Serial No.: 09/762,223
Filing Date: May 7, 2001
Applicant(s): ANSON et al.
Title: DEVICES AND METHODS FOR THE REPAIR OF ARTERIES

**REQUEST FOR REINSTATEMENT OF PATENT
APPLICATION PRESUMED ABANDONED BY USPTO
(37 CFR §1.8(b))**

**COMBINED PETITION UNDER 37 CFR §1.181(a)(1)
TO WITHDRAW PREMATURE FINAL REJECTION /
TO WITHDRAW HOLDING OF ABANDONMENT
(37 CFR §1.113(a); MPEP 706.07(c))**

Figure 10

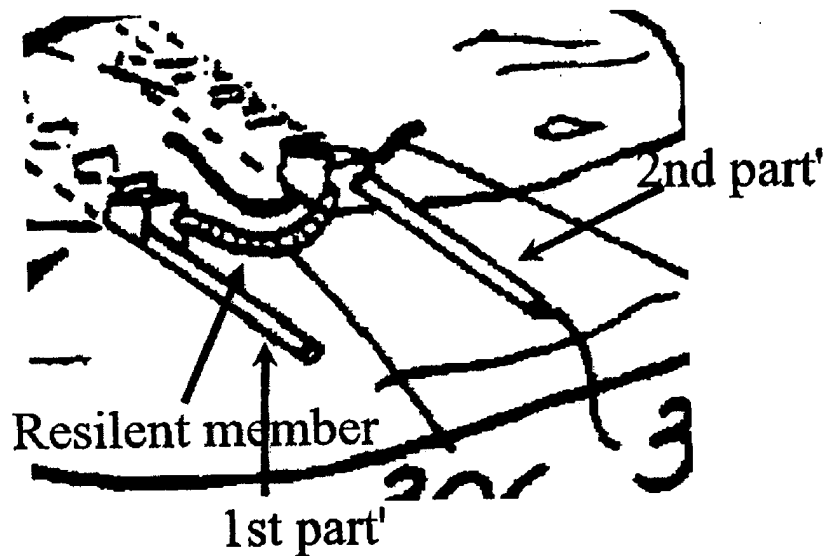
14. The applicant describes a helical structure in part C, yet there is no mention of a helical structure in the specification and no support in the diagrams to substantiate the claimed subject matter.

- Please delete the paragraph situated at page 14 lines 21-24 of the specification and insert the following replacement paragraph in its place (with support for the amendment being found in claim 62, as well as in Fig. 10 in particular):

The stabiliser (Fig. 10) consists of two elastically deformable thin strips of metal (47) which, when unconstrained form a nominally circular shape (46). The two strips are riveted together (45) at the leading edge and are riveted onto a short metal tube (49) which has been arranged to retract within a catheter sheath (48). **The metal tube (49) serves as a locating member for locating the device with respect to a catheter, and the distal portions of the strips (46) define support members (320) for supporting the catheter on the inner wall of an artery or graft. The proximal portions of the strips (46) then serve as resilient members (322) which connect the locating member (49) and the support members (320), with the resilient members (322) biasing the support members (320) toward the artery wall. As the resilient members (322) bias the support members (320) toward the artery wall, they reduce the distance between the end of each support member (322) and its resilient member (322), thereby causing the support member (322) to bow radially outward with respect to the locating member (49).**

Figure 14

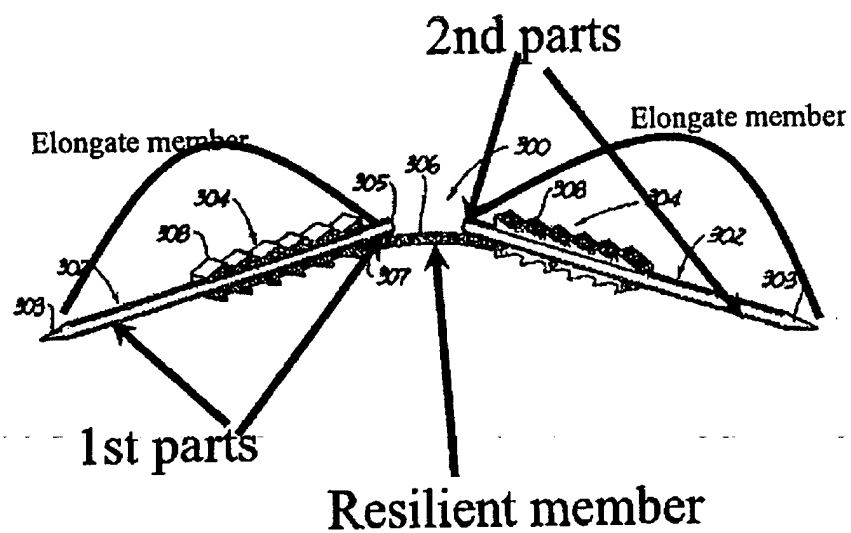
17. Regarding claim 68, the elongate member of the Green device has the capability of being in an open configuration, figure 14, and a retaining configuration, figure 1, where in the 1st and 2nd parts are closely spaced, wherein the device is biased towards the closed configuration.

18. Regarding claim 69, the fixator has 2 parts that are sharpened, allowing it to pierce an artery and a graft (see figure 14).

Reconsideration of the rejections is requested.¹ Initially, note that claim 68 recites elongated members (in the plural). If *Green* is regarded as having a pair of elongated members 302/303/308/304 (as shown in the Examiner's second drawing in the Office Action), *Green* neither discloses nor suggests bending each of the elongated members as recited in claim 68; rather, each elongated member stays straight, with the bioresorbable connection between them (see column 8 line 62 onward) being bent. Note that the Fig. 10 apparatus is shown "spread" merely because the bioresorbable connecting material is not rigid, and that the apparatus is not in fact bent when deployed: as depicted in Figs. 7-9 and described in the specification, the *Green* apparatus is driven forward in a U-shaped form, see Figs. 13 and 14, with each "arm" being in parallel and being driven by needle 302, see Figs. 13 and 15, and the apparatus remains in this configuration when deployed, without the spacing between the arms being varied. After deployment, the bioresorbable connection between the arms dissolves while the arms remain in tissue as retaining spikes (see, e.g., column 10 lines 55-60). Thus, *Green* has no teaching or suggestion that a fixator may include an elongated member (much less multiple elongated members) wherein each elongated member is bent from a linear form to a form wherein its ends are closely spaced, such that each elongated member retains a graft and artery together. *Green* is simply a rather conventional surgical staple having linear arms which remain in linear form when installed in tissue, but the "bridge" of the staple is made of dissolving (and flexible) material. Consider that this flexible material cannot maintain the arms in a closely spaced condition (and in fact it cannot hold the arms in any fixed location owing to its flexibility), and thus there is no way to use the *Green* apparatus to fix an artery and graft in the manner claimed, nor is there any apparent reason why one would be motivated to modify the *Green* apparatus to provide this capability. In

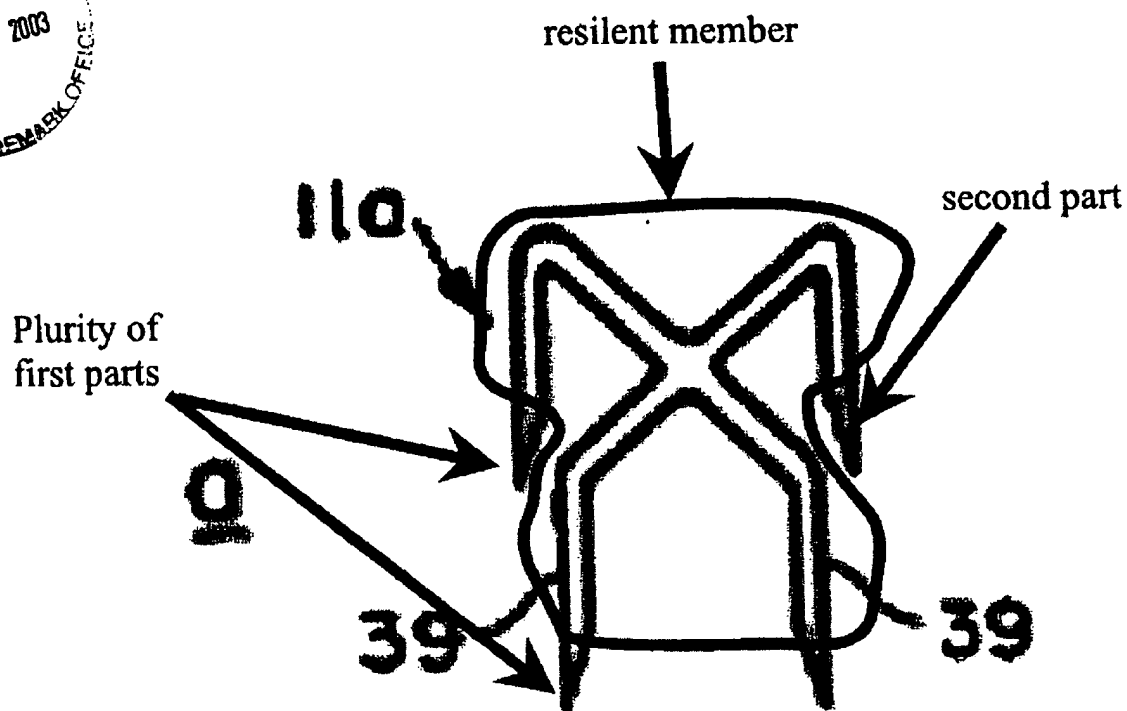
15. Regarding claim 63, the Krumme fixator can hold a graft.
16. Regarding claim 64, the Krumme device illustrated in figure 5a contains two elongated members (one elongated member has been painted gray in the attached diagram, the other one is white.) The elongated members have an open and closed configuration. In the open configuration, the first and second members are spaced; in the closed configuration, the first and second members are closer together.
